Additional Exhibit to accompany the HDC Exemplary Buildings Balanced Ventilation with Heat Recovery Guidelines

Code Modification or Alternate Request

Address: 1911/1923 22nd Ave S

PROJECT: DESC Hobson Place 22nd Ave S (South Phase) – Supportive Housing SUBJECT: 4" Duct Run Connection to Supply & Exhaust Mains inside Building FROM: Eric Vander Mey, PE (206-285-7114, ericv@rushingco.com) Anthony Savedra, EIT (206-462-7668, anthonys@rushingco.com)

SECTION THROUGH LEVEL 7 CORRIDOR

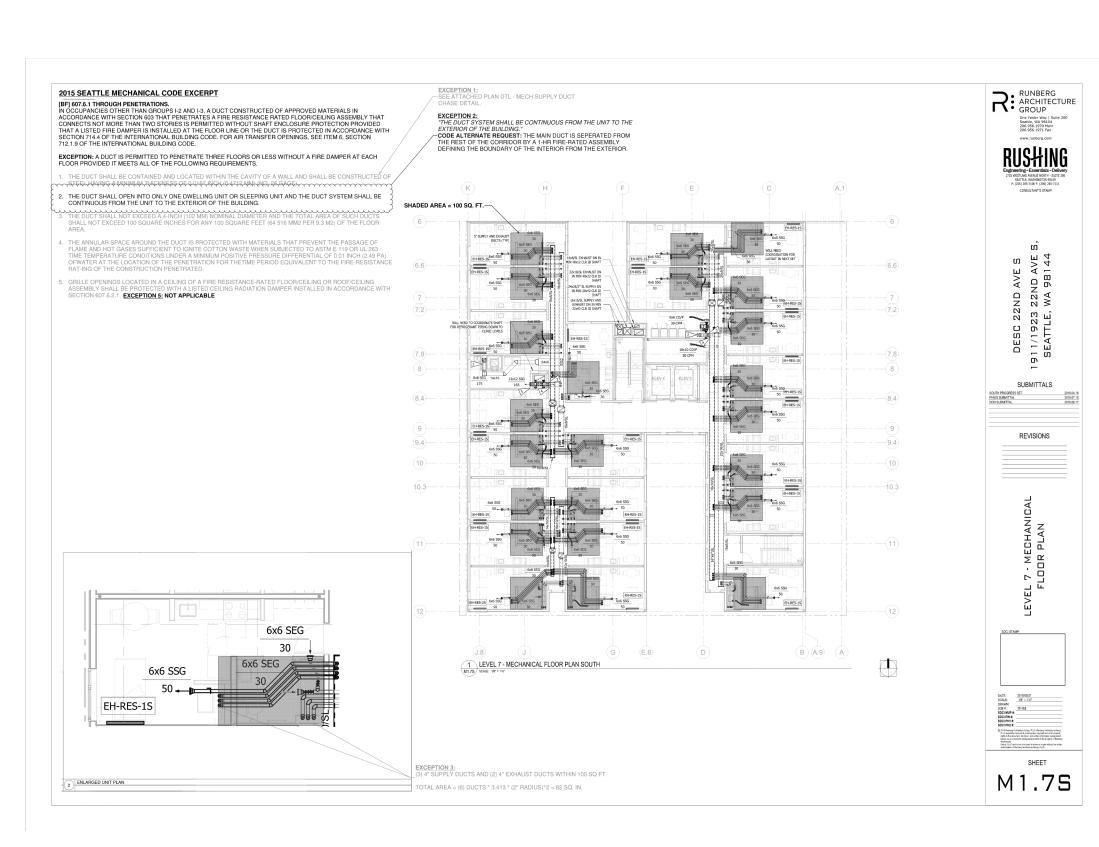
Allow 4" round supply and exhaust duct runs for each residential dwelling unit to connect to the supply and exhaust horizontal duct mains above a 1-hour rated horizontal ceiling assembly above the corridor on the upper floor of the building (L7). See attached drawings for proposed ceiling assembly.

The 1-hour horizontal ceiling assembly in the corridor and the 1-hour vertical corridor fire partition walls provide a rated boundary between the dwelling units and the supply/exhaust duct mains above the corridor (See "Section through Level 7 Corridor" clip below). Additionally, by providing legally required standby power (similar to what is required for subduct exhaust fans systems at shaft penetrations without fire/smoke dampers) this provides a more reliable power source to maintain continuous supply air and exhaust airflow for the duct systems which will help to remove any smoke from the occupied spaces. In our professional opinion, the legally required standby power at the unit and the 1-hour fire-rated horizontal ceiling assembly (not required by other provisions of the SBC) separation provides an equivalent level of protection to the 1-hour rated horizontal roof/ceiling assembly required for Type IIIA construction to separates the outdoor

The 1-hour horizontal ceiling assembly in the corridor and the 1-hour vertical corridor fire partition walls provide a rated boundary between the dwelling units and the supply/exhaust duct mains above the corridor (See "Section through Level 7 Corridor" clip below).

Each of the homeruns are located in 2x10 stud wall and are fire caulked at the top and bottom plate where they penetrate the rated horizontal assemblies. Additionally, the ducts will be fire caulked when they penetrate the vertical walls of the 1-hour rated residential corridor fire partition walls above the 1-hour rated horizontal assembly ceiling in the corridor. Based on this configuration the horizontal supply and exhaust duct mains above the corridor ceiling are separated from the rest of the building.

Seattle DCI Use Only	
☐ Approved ☐ Approved with Amendment ☐ Denied Reasons:	Approved Subject to Errors & Omissions	Digitally signed by Richard Pellinger Date: 2019.10.18 17:12:30 -07'00'

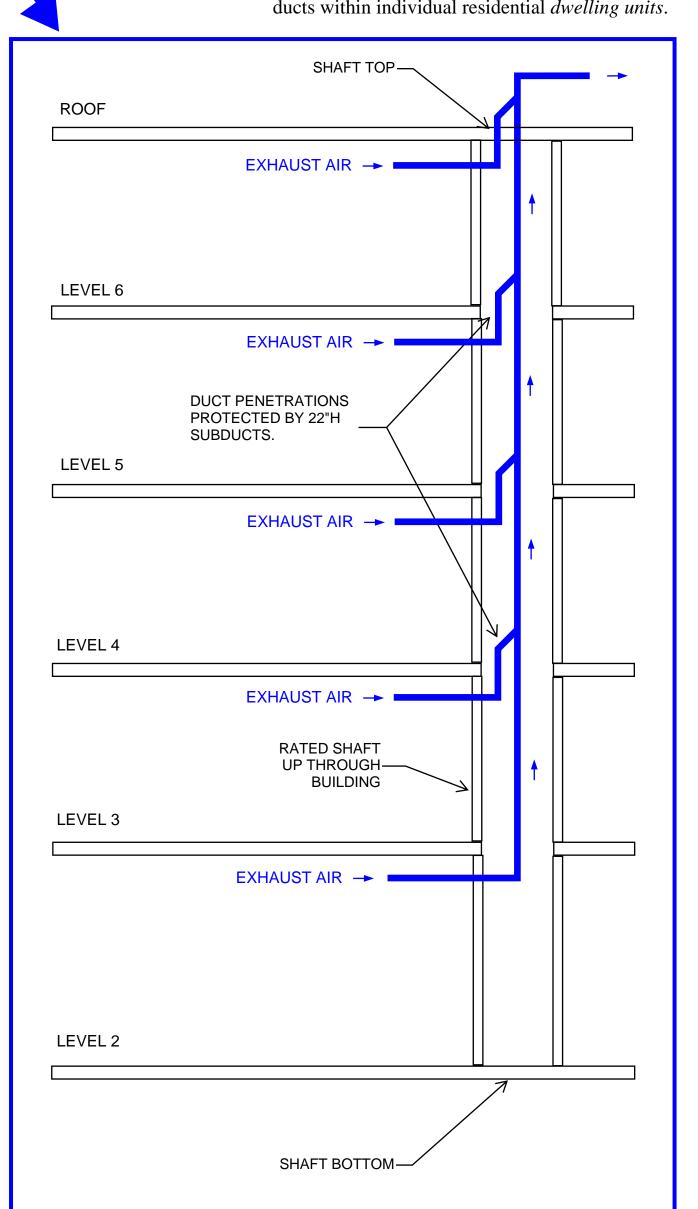
EXCEPTION 1.1 ALLOWS FOR OMISSION OF FIRE DAMPERS AT EXHAUST DUCTS WHERE STEEL SUBDUCTS ARE PROVIDED

EXCEPTION 2 ALLOWS FOR OMISSION OF SMOKE DAMPERS AT EXHAUST DUCTS WHERE STEEL SUBDUCTS ARE PROVIDED FOR CERTAIN USES AS LONG AS LEGALLY REQUIRED STANDBY POWER IS PROVIDED AT SUBDUCT EXHAUST FAN

THROUGH PENETRATIONS OF RATED HORIZONTAL ASSEMBLIES WITHOUT FIRE DAMPERS AS LONG AS ALL THE **FOLLOWING ARE TRUE:** a.) DUCT DOES NOT PENETRATE MORE THAN 3 FLOOR **ASSEMBLIES** b.) DUCT IS WITHIN A WALL CAVITY (NOT IN A SHAFT) c.) DUCT IS ONLY OPEN TO ONE **DWELLING UNIT** d.) DUCT HAS MAX DIAMETER OF 4" ROUND e.) TOTAL DUCT AREA DOES NOT EXCEED 100 SQ. INCHES IN 10'x10' FLOOR AREA
